## Yass Landscape Guardians Rye Park WindPEG Submission 2016

### Biodiversity Assessment Addendum March 2016

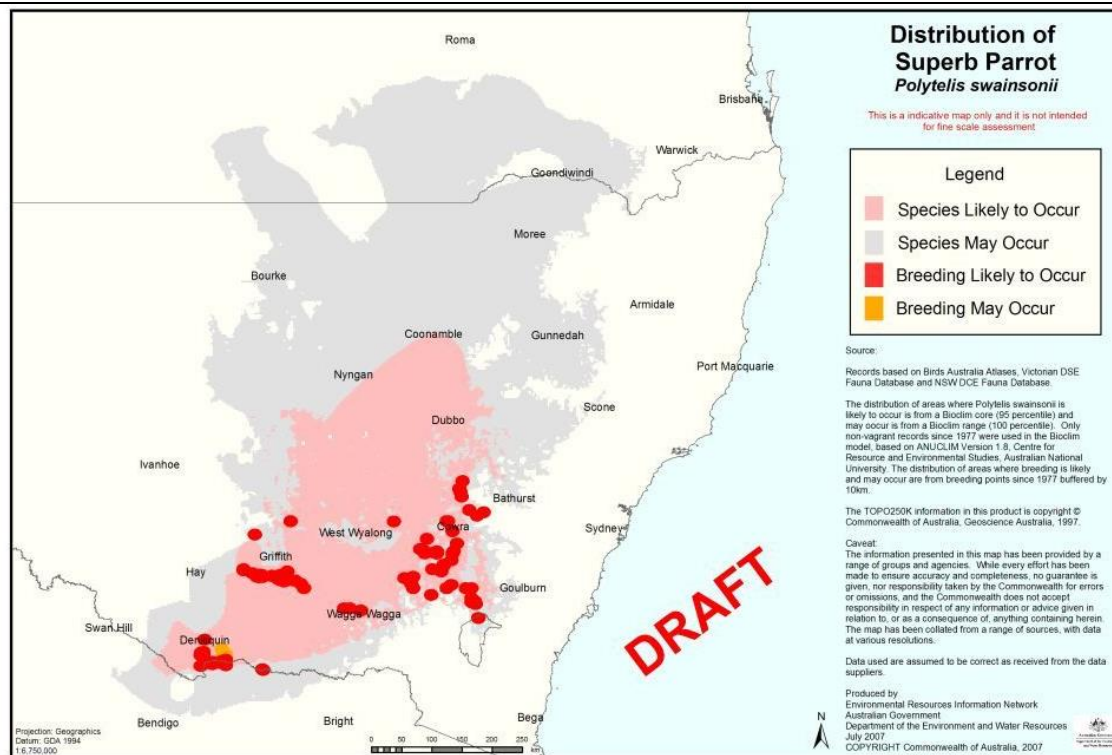
| 4.7 |  | <p><b>Wedge Tailed Eagle Ecology</b><br/> <i>The site-specific collision risk at Rye Park is expected to be much lower than averages cited above. It has been possible to build upon lessons learnt elsewhere to reduce the risk of collision at Rye Park by minimising high risk turbine placements.</i></p> | <p>The following article proves 2 things:</p> <ul style="list-style-type: none"> <li>a) Wedge tailed eagles (along with numerous other species) are prone to Blade Strike;</li> <li>b) There is insufficient information available to determine the risk.</li> </ul> <p>As per WindPEG's effects on human health their impact on animal health whilst significant is not fully understood and our knowledge is limited due to an inability to obtain reliable data from private WindPEG operators.</p> <p>Further the impact of this project on this species ignores the cumulative impact of other approved "like" projects such as Conroys Gap and Yass Valley WindPEGs in the Yass region on regional raptor populations.</p> <p><b>As per Human Health the precautionary principal should be applied and this project should be refused.</b></p> <p><b>Broad scale and domestic Solar projects with minimal environmental footprints should be supported by both State and Federal Governments as legitimate renewal energy alternatives.</b></p> <p><i>Wind-farms and collisions</i></p> <p><i>It is unfortunate that data on bird strikes with wind farms are only publicly available from the Tasmanian wind farms. With no other data available, the list of bird and bat species recorded (Table 1) as colliding with the Woolnorth Holdings two wind farms in north-west Tasmania was used to investigate the potential overlap between species observations and operating and proposed wind-farms nationally. Note: The list of affected species in Table 1 does not</i></p> | <b>Total Project Refusal</b> |

If a species assemblage that appears to be vulnerable from Tasmanian data also occurs widely on the mainland, then without additional strike data, we can only hypothesize that this assemblage would be also be vulnerable at mainland wind-farms in areas of similar observational density. Note that the Tasmanian Wedge-tailed Eagle is a subspecies, so inference about other Wedge-tailed Eagle subspecies on the mainland is not proven.
